**East Side Coastal Resiliency Project:
Final Scope of Work to Prepare a Draft Environmental
Impact Statement**

April 5, 2019

CEQR No: 15DPR013M

Source: View Corridors - AKRF

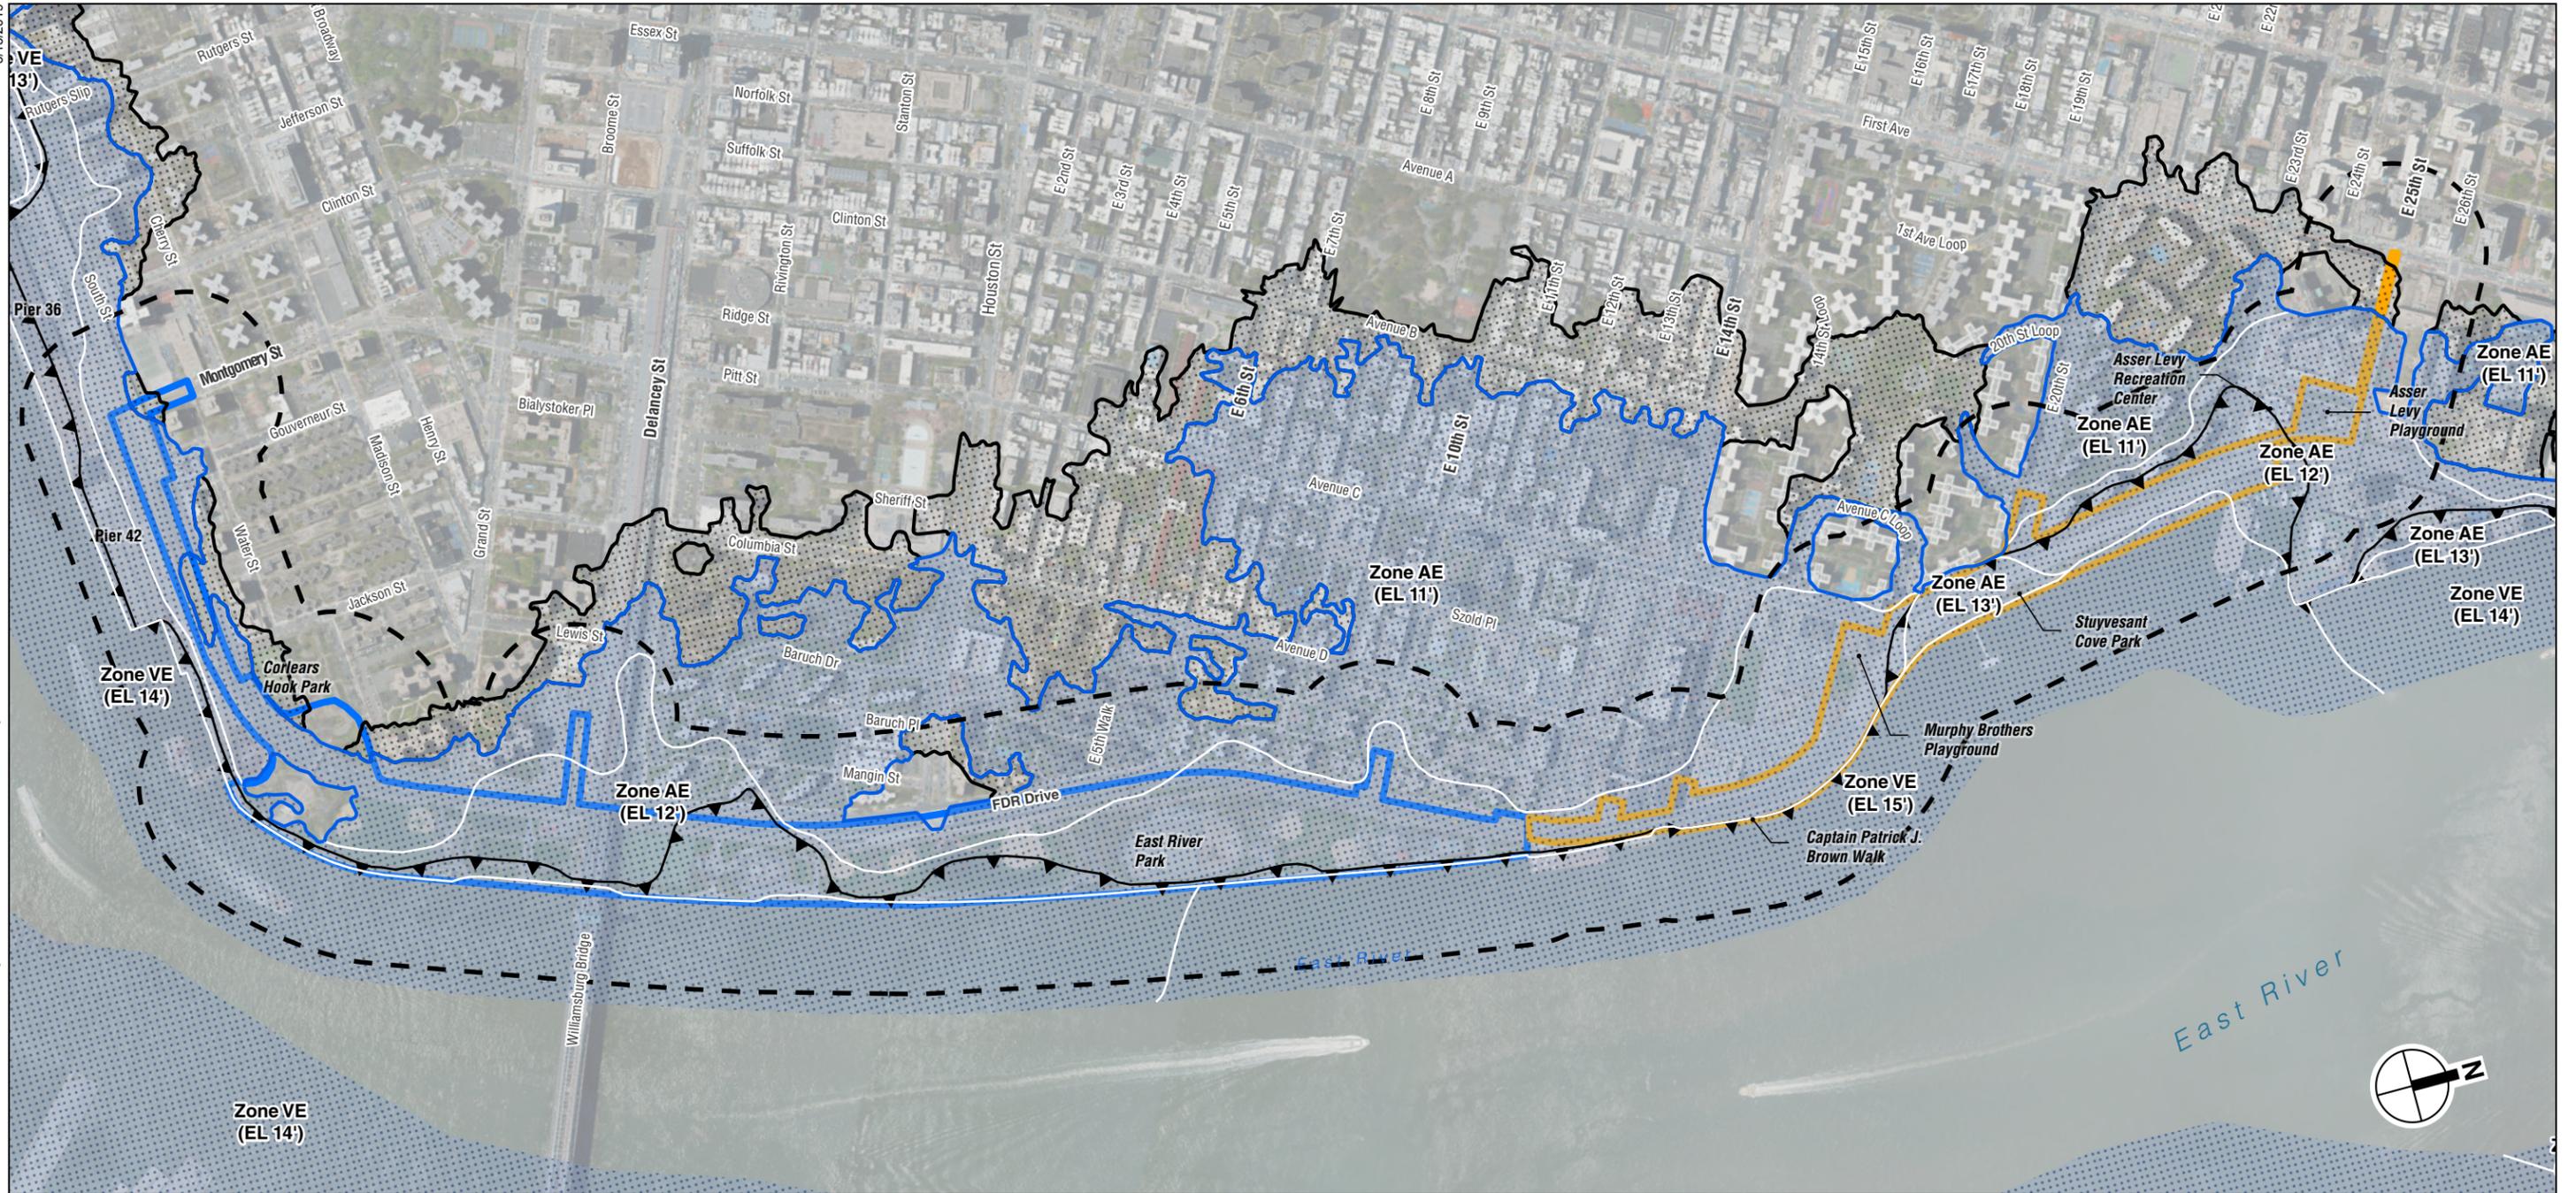
Comment 67: Correction to Figure 18: The northward Avenue C view corridor (toward the Queensboro Bridge) is an important view corridor, but here is not shown by any arrow in the drawing. I suggest that it be included and also include the direction that whatever deployables are going to be utilized are oriented so that this view corridor is preserved. (Scheyer)

Response: As described in the Draft Scope of Work, Figure 20—Urban Design and Visual Resources, Study Area and Visual Corridors—provided a preliminary identification of existing inland views to the waterfront. Figure 20 in this Final Scope of Work has been modified to include the northward view corridor from Avenue C, which will be evaluated in the EIS.

- Project Area One
- Project Area Two
- Collected Noise Level Measurement Locations
- Supplemental Noise Monitoring Locations

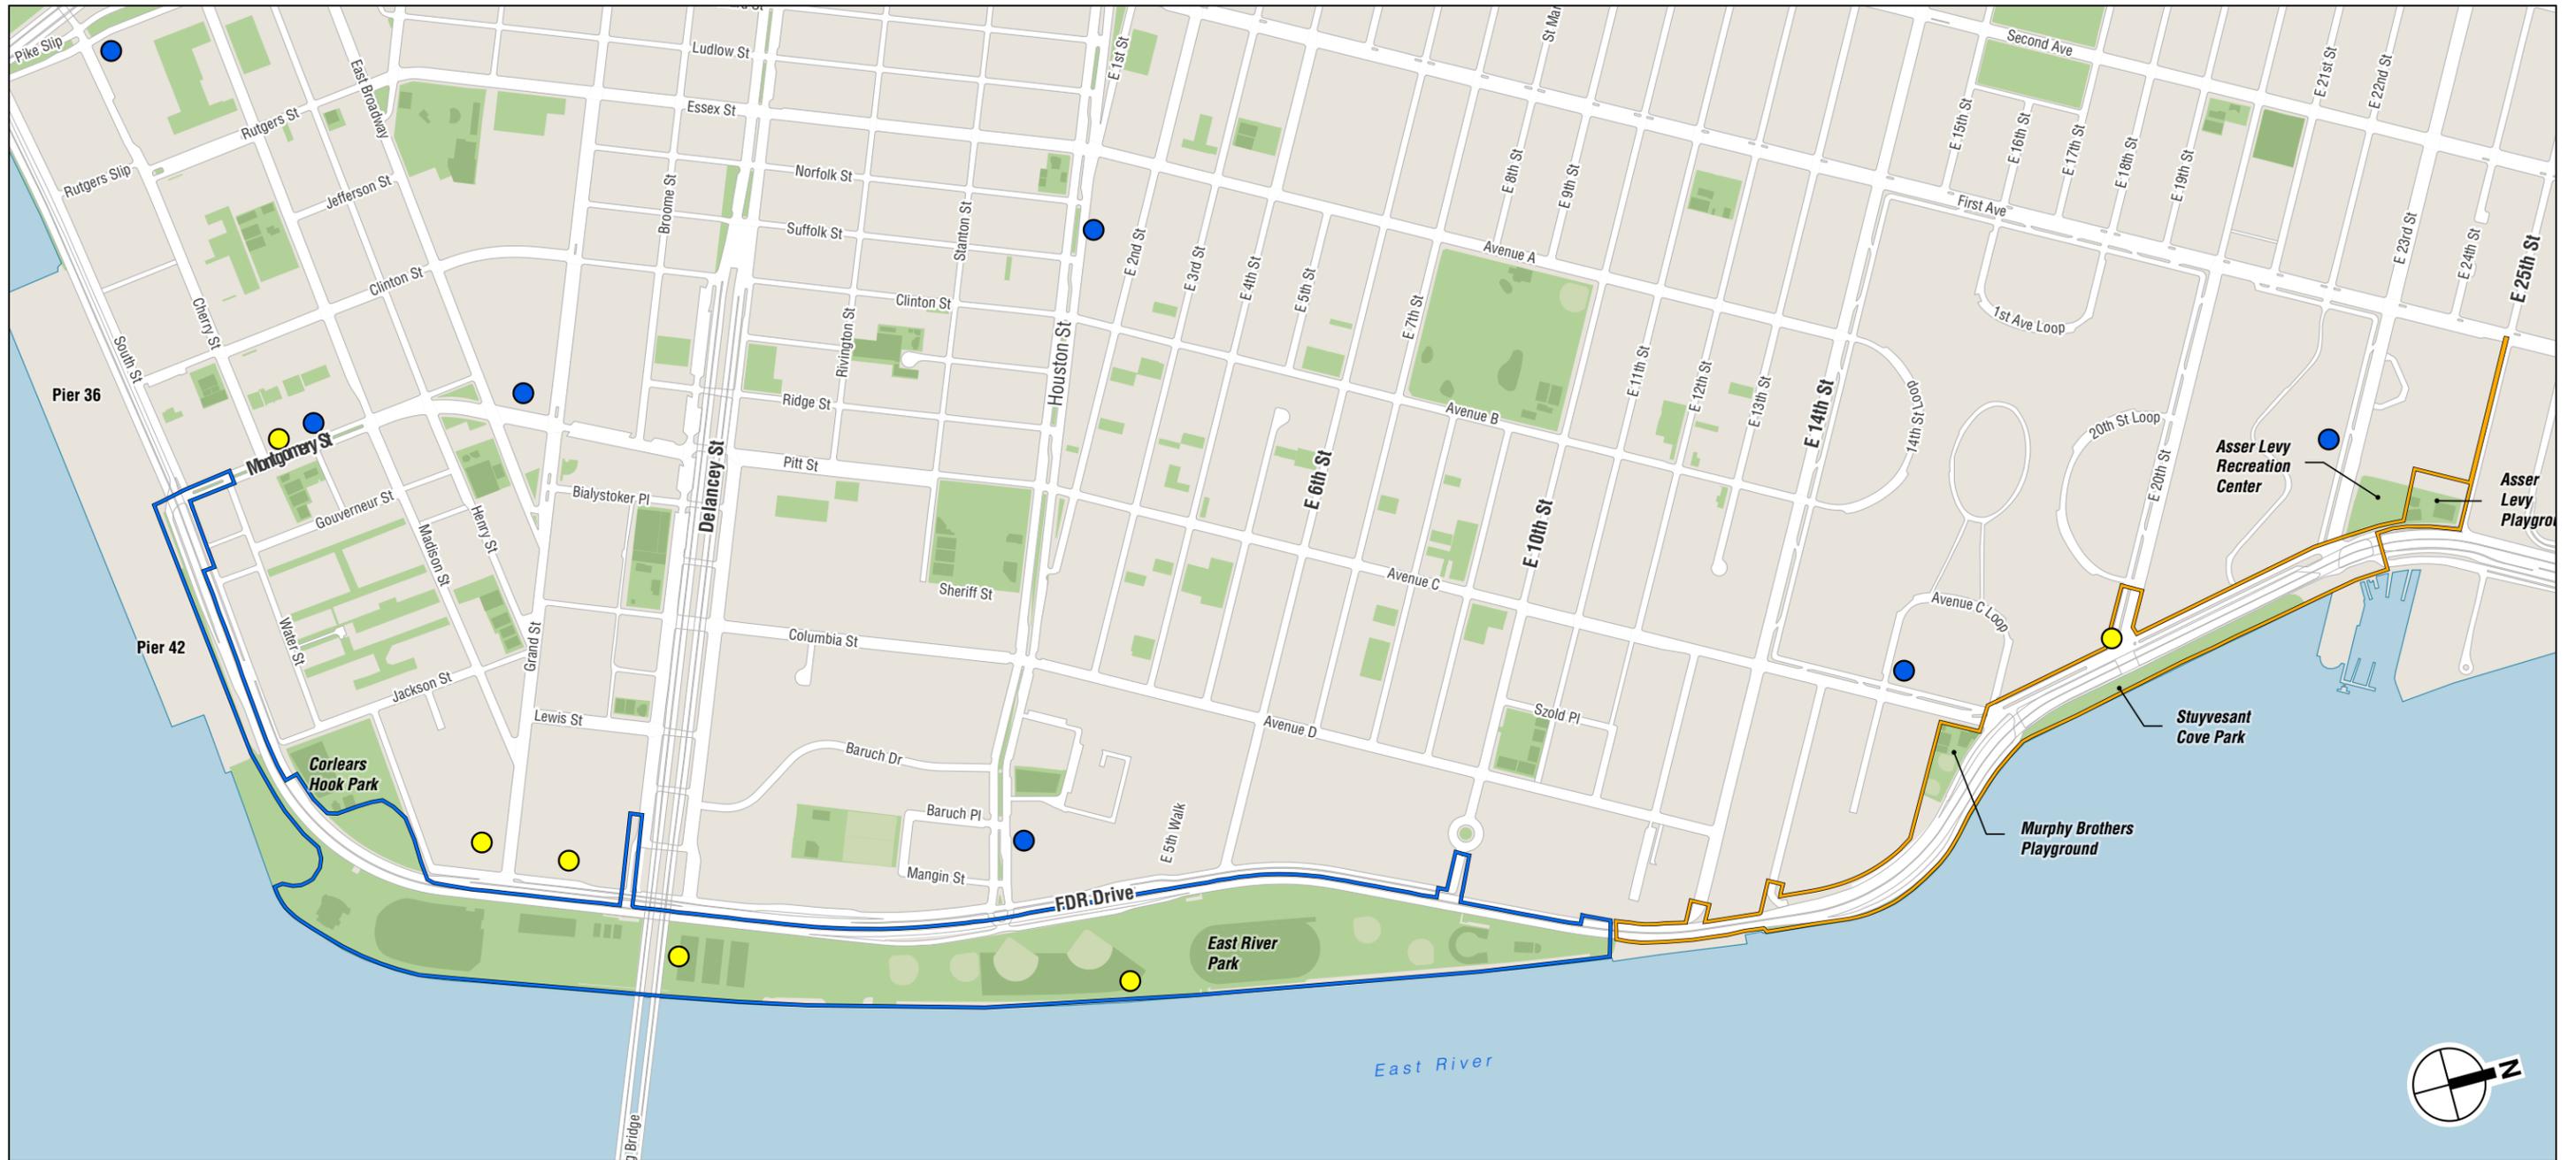
Comment 85: With regard to Figure 21, the noise monitoring locations, I was surprised that there is no noise monitoring station at East 10th Street, since there's consideration for improving the East 10th Street bridge. (Smolney)
